NOTICE OF A TYPE I DECISION ON A PROPOSAL IN YOUR NEIGHBORHOOD

CASE FILE NUMBER: LU 19-252868 HR
WINDOW ALTERATIONS ON SOUTH FAÇADE OF HOUSE

Proposal:
The applicant proposes to raise the sill heights on two windows on the south-facing façade to accommodate a new master bath on the second floor. The bottom sills of the easternmost three windows on the second story of the south façade will all match. The existing windows will be re-milled and re-installed at the new dimensions. The existing vinyl siding will be patched to match existing where the windows are reduced.

South Elevation w/ Proposed Window Reductions

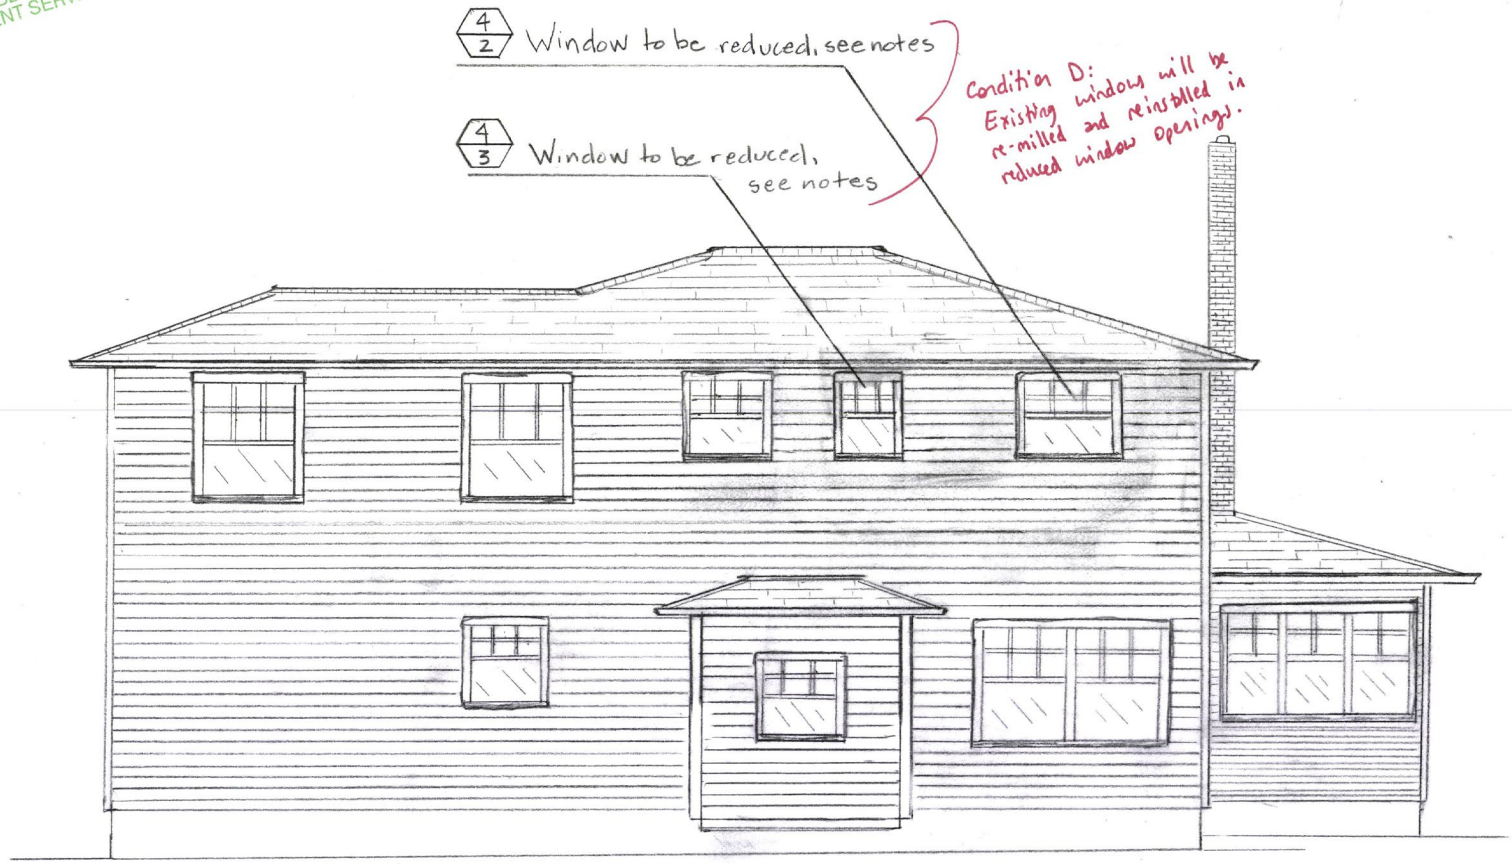
> **Findings for 1, 2, 4, 7, 8, 9, and 10:** The proposal includes the reduction of two windows on the south façade to accommodate a new second-level bathroom. The sills of the windows will be raised in order to match the height of the existing center window of the upper level; header heights are unchanged. The original windows will be re-milled/resized so the original, historic materials will be retained and the reduced windows will be located in the same depth of the wall as the existing. As such, the modified sashes will visually match the existing condition by referencing profile, material, and recess depth, and will better align with the adjacent windows. The new wall areas will match the existing vinyl siding.
>
> While the proposal results in the removal of some historic sash material, the proposal will retain and reinstall the existing/original windows. Thus, the historic character of the resource will be retained, and the resource will remain a physical

record of its time, place, and use. To ensure the retention of the existing/ original windows and that the above-mentioned approval criteria are met, staff has added Condition of Approval "D" that the existing/ original windows be retained and reinstalled in the reduced openings. The re-milled sashes remain compatible with the resource and the District and preserve the essential form and integrity of the resource.

D. The existing/original windows will be re-milled and reinstalled into the reduced window openings.
